RANCHO SANTIAGO COMMUNITY COLLEGE DISTRICT

ADDENDUM NO. 02

Bid #1491 BUILDING G HVAC Replacement Project
at
SANTA ANA COLLEGE

Project ID #2957.1, DSA #04-123961

SHEET
M1.00

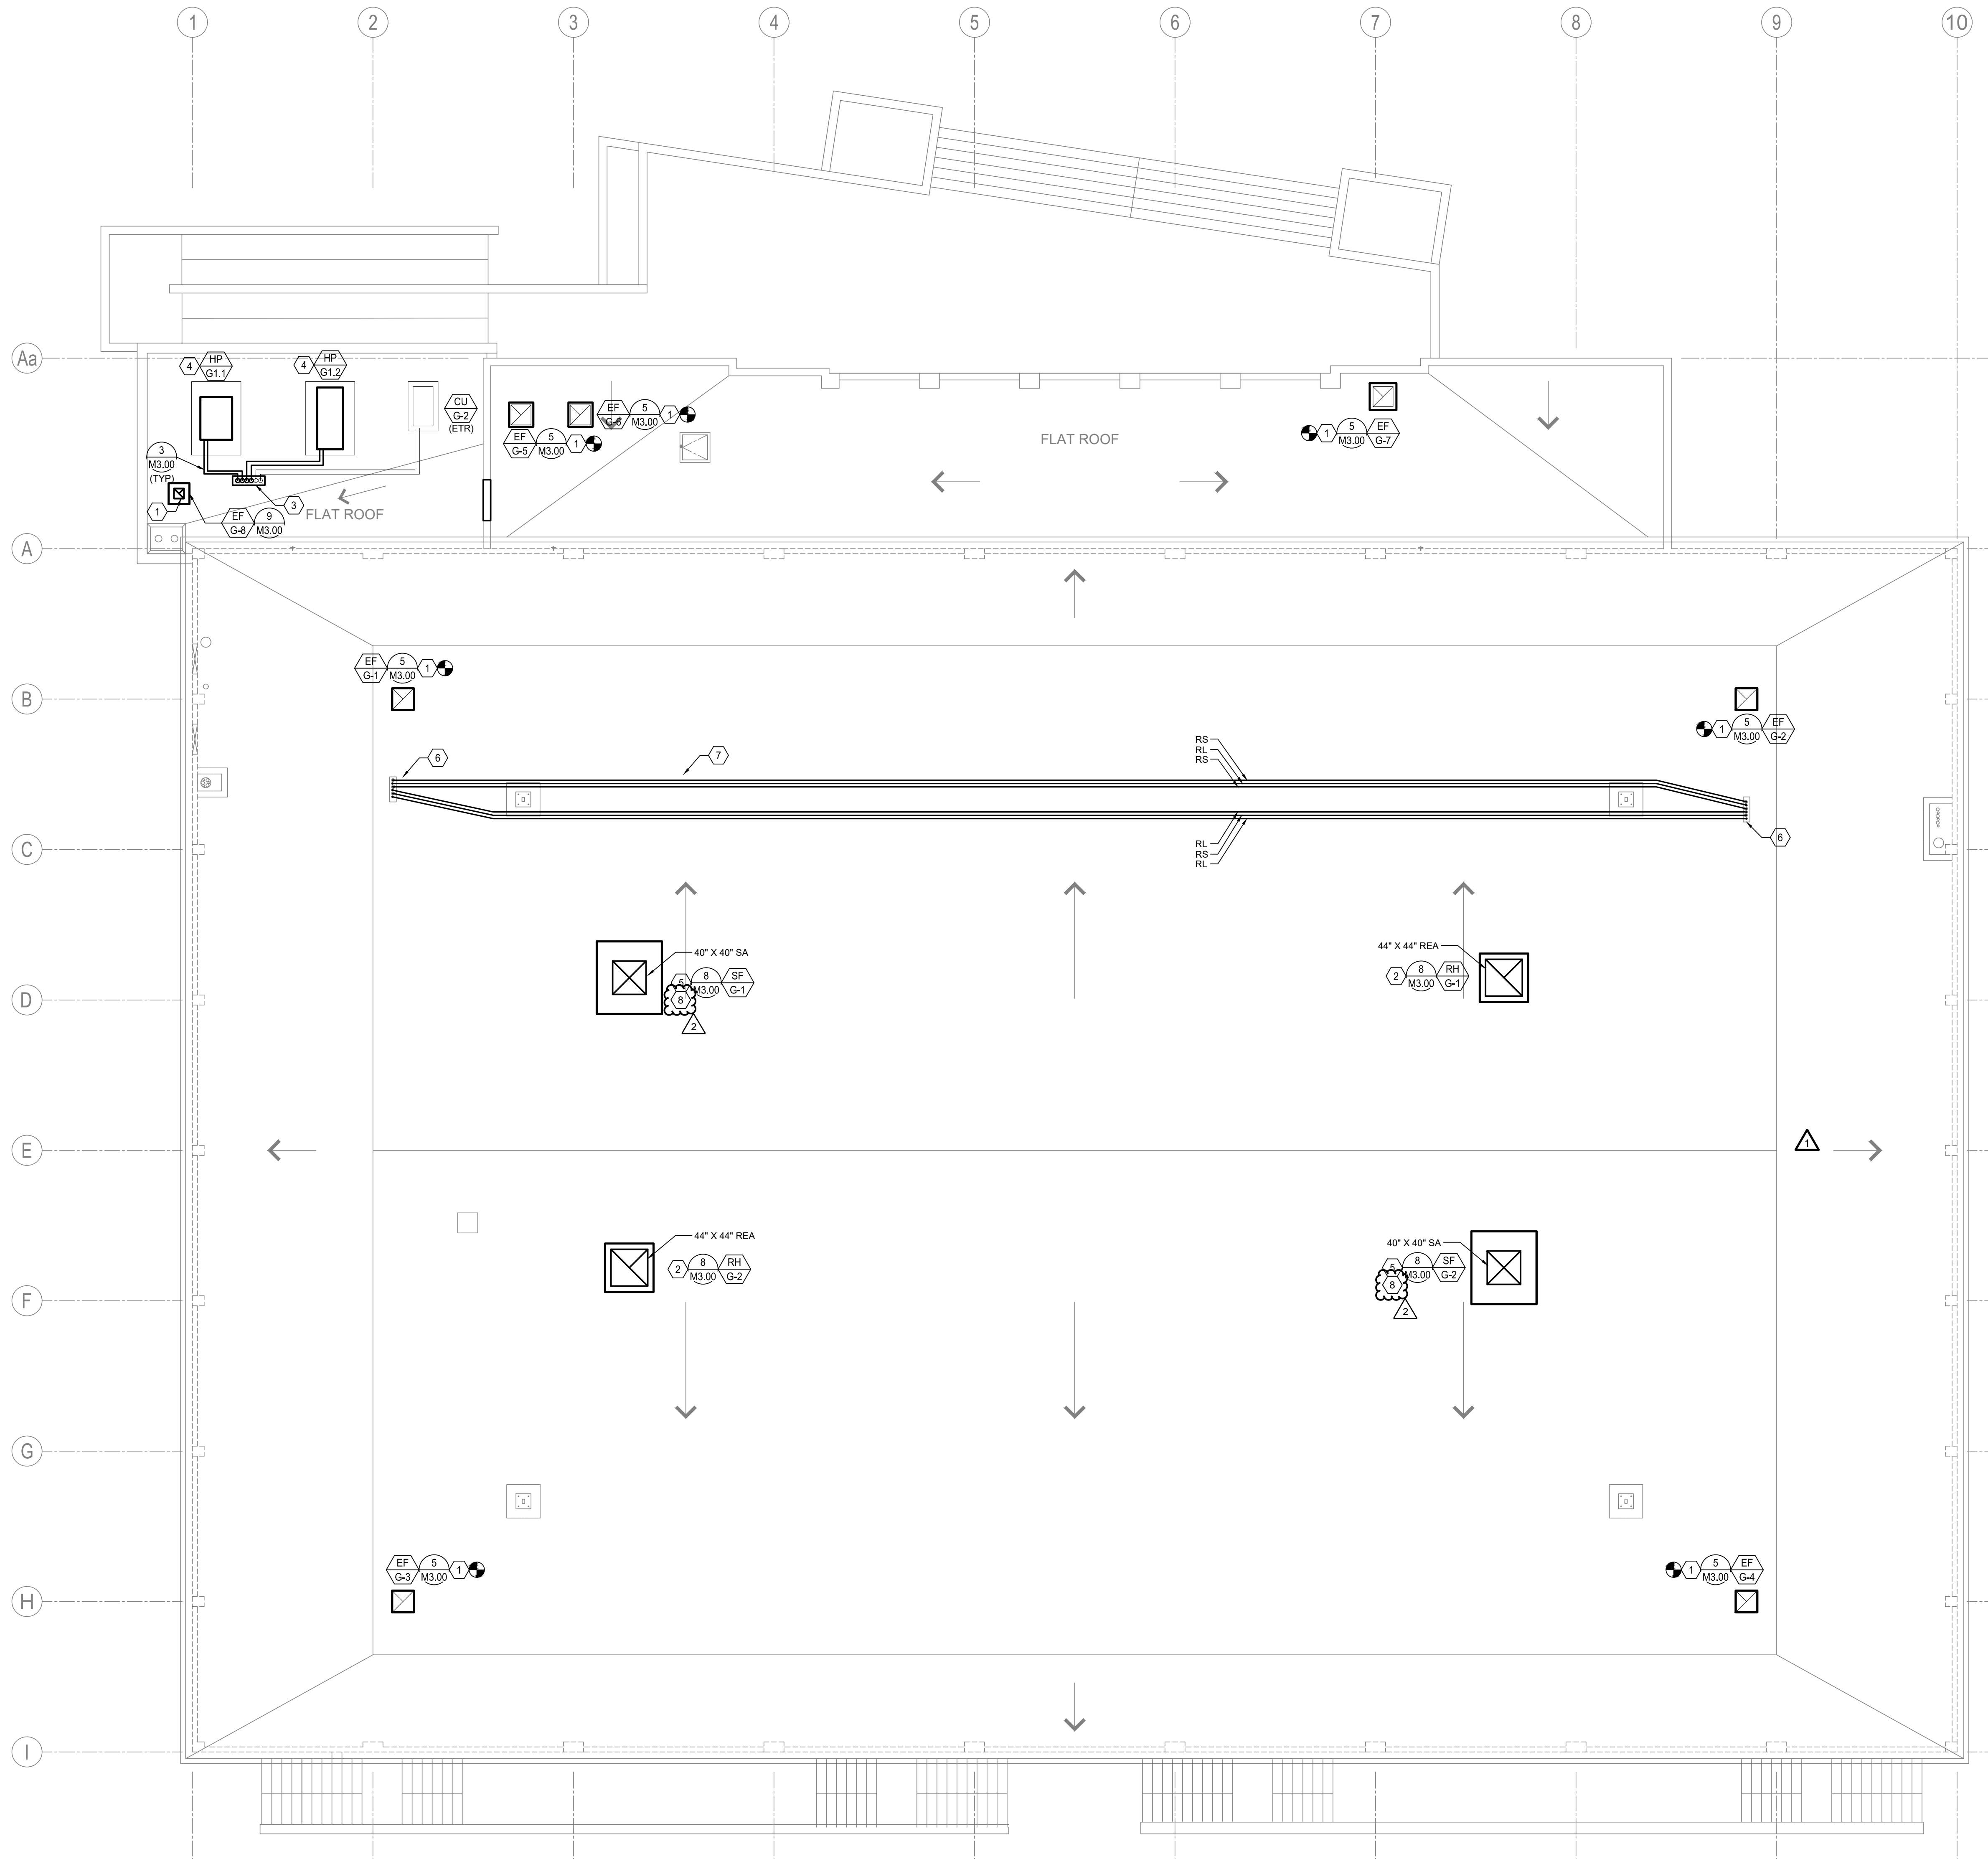
1. SHEET m1.00, MECHANICAL ROOF PLAN (BUILDING 'G')

- a. Inserted: Keynote 8 at SF G-1 and SF G-2 with the statement, "DUCT-MOUNTED DETECTOR TO BE LOCATED SUCH THAT DETECTOR IS ACCESSIBLE FROM THE ROOF FOR TESTING."

- ROOF PIPE SUPPORT REFER TO DETAIL 2/A205, TYP.
 - DUCT MOUNTED DETECTOR TO BE LOCATED SUCH THAT DETECTOR IS ACCESSIBLE FROM THE ROOF FOR TESTING.

SHEET
E0.50

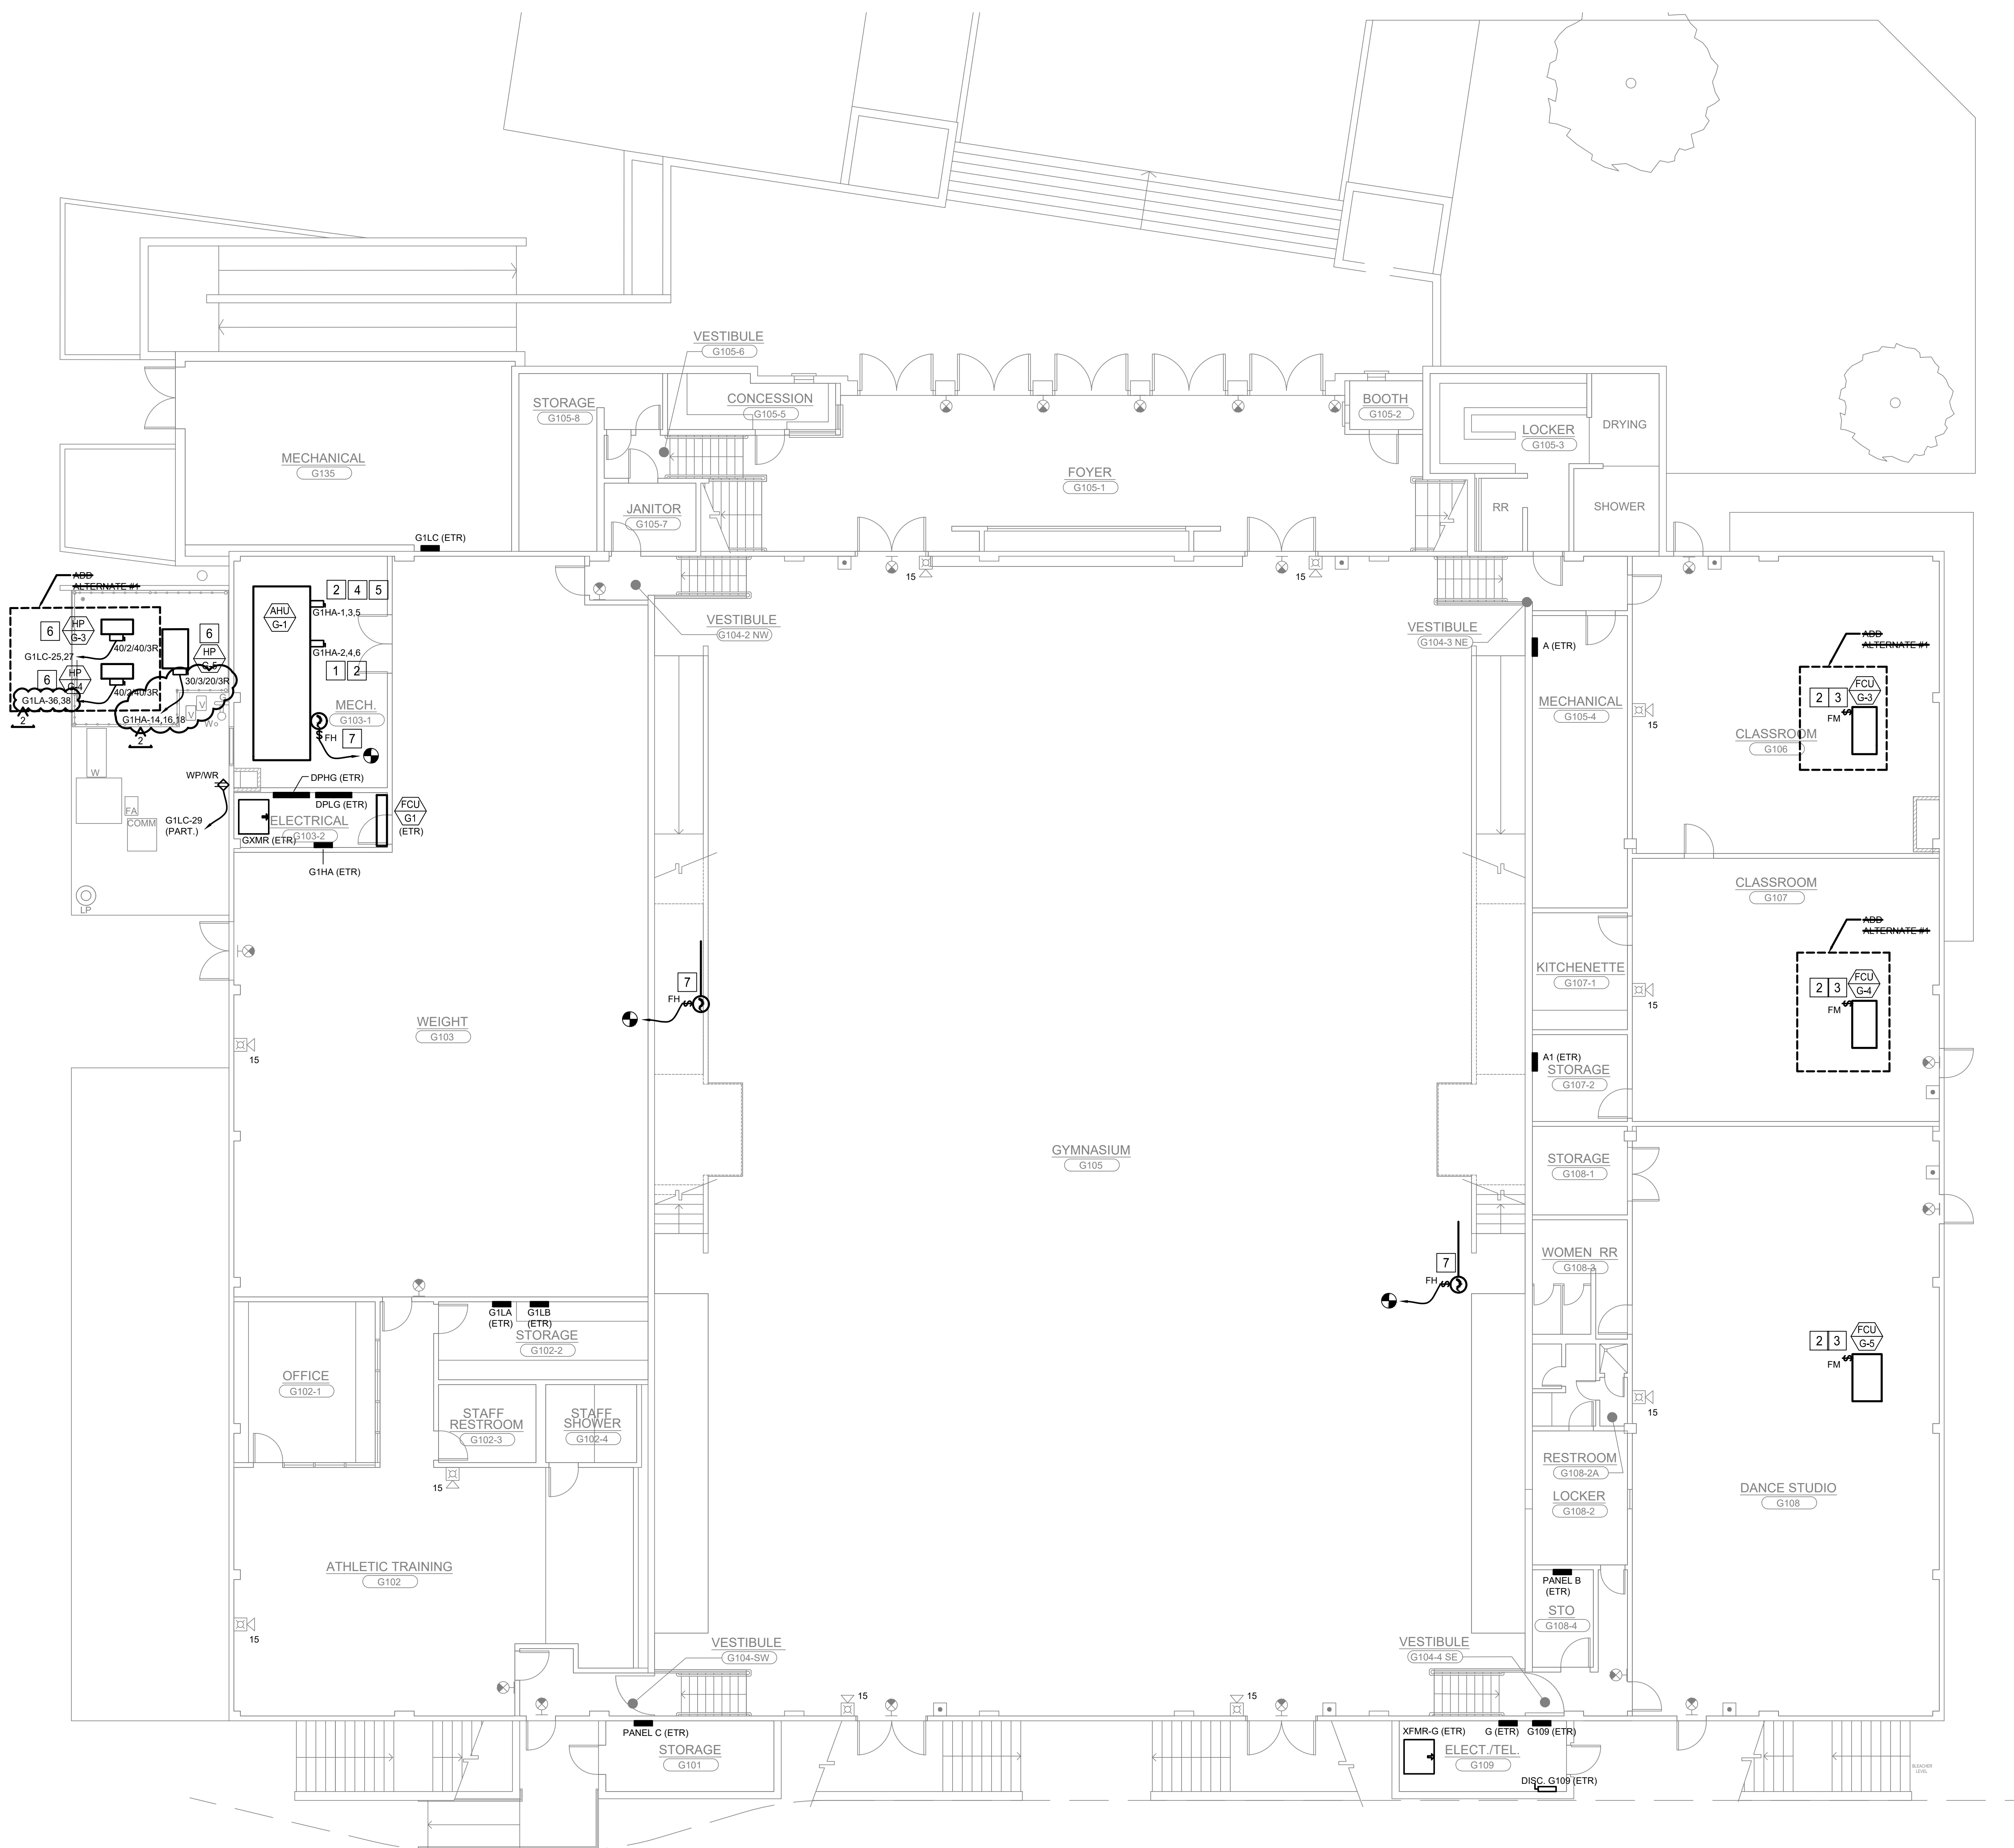
1. SHEET E0.50, ELECTRICAL FIRST FLOOR PLAN BUILDING 'G':

- a. Removed: Circuit designation at HP G-4 and HP G-5.
- b. Inserted: "G1LA-36,38" at HP G-4 and "G1HA-14,16,18" at HP G-5.

SHEET
E1.00

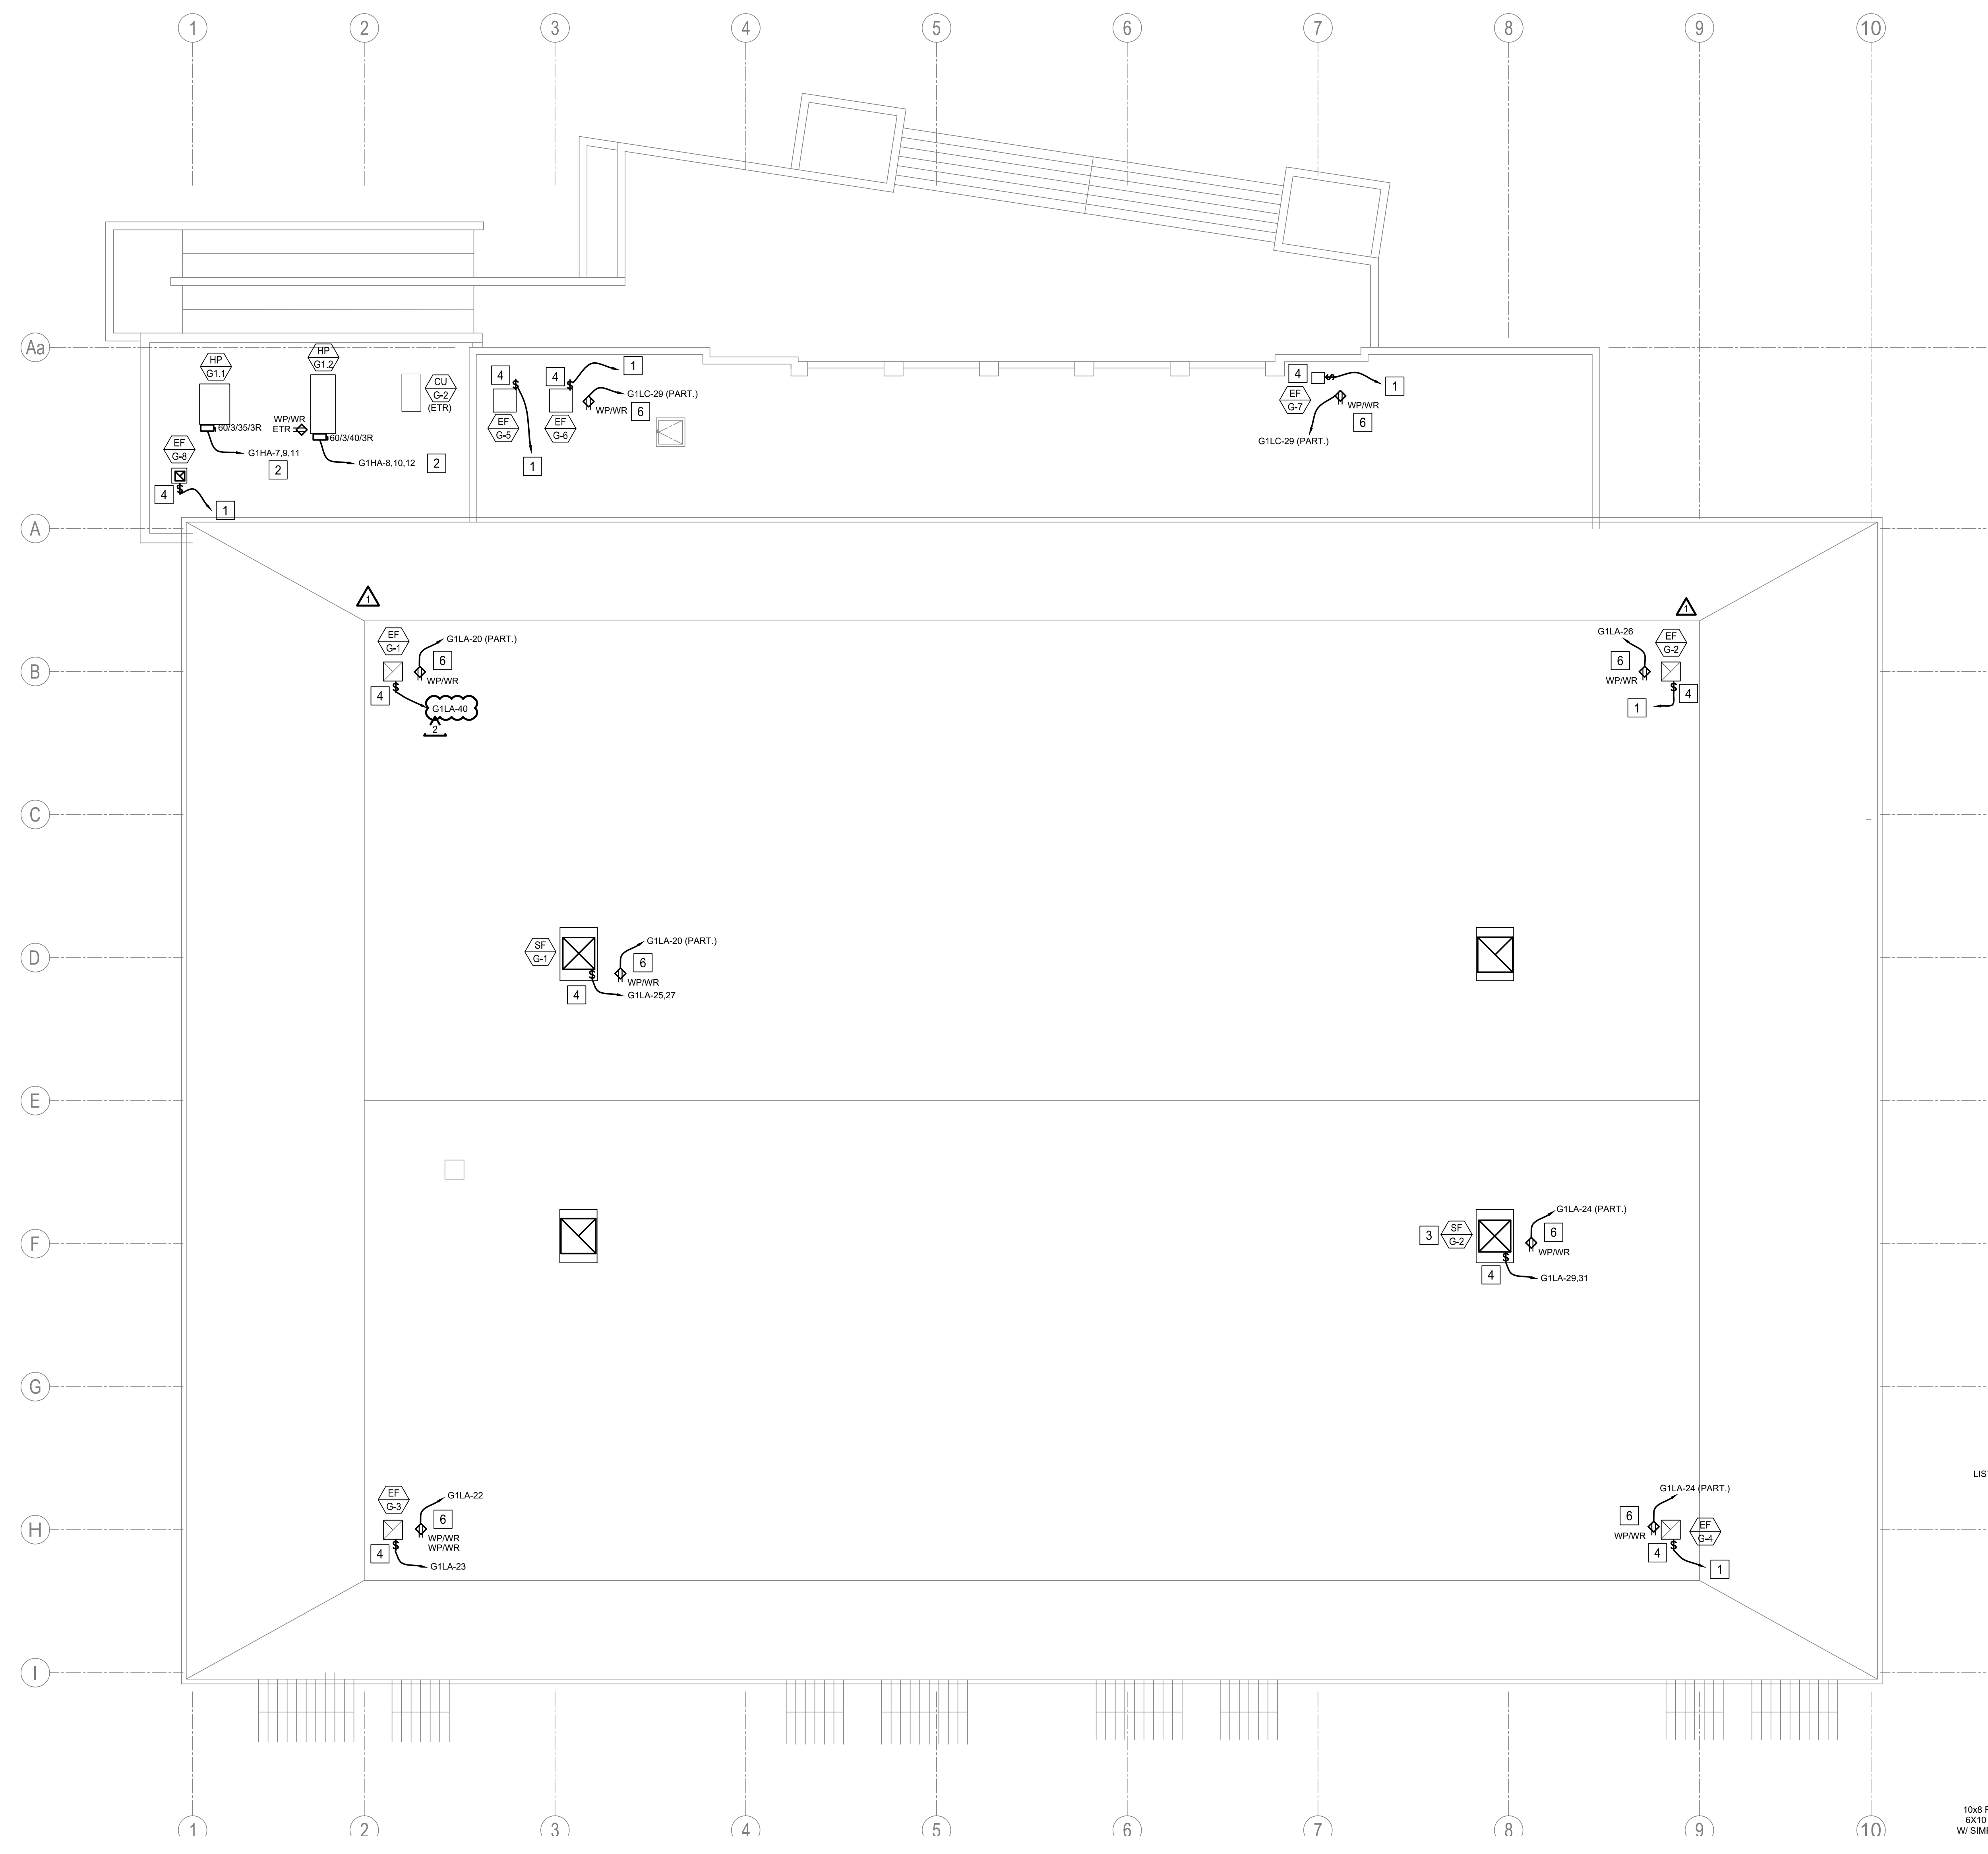
2. SHEET E1.00, ELECTRICAL ROOF PLAN BUILDING 'G':

- a. Removed: Circuit designation at EF G-1

- b. Inserted: "G1LA-40" at EF G-1
3. SHEET E3.00, ELECTRICAL ONE-LINE DIAGRAM:
 - a. Inserted: "PRIOR TO DEMOLITION OF ANY EXSTING LOADS, 30-DAY METERING WAS CONDUCTED IN ACCORDANCE WITH CEC 220.87 FROM 12/23/2025 TO 02/04/2026. THE HIGHEST RECORDED PLASE AMPERAGE FOR EACH PANEL WAS AS FOLLOWS:
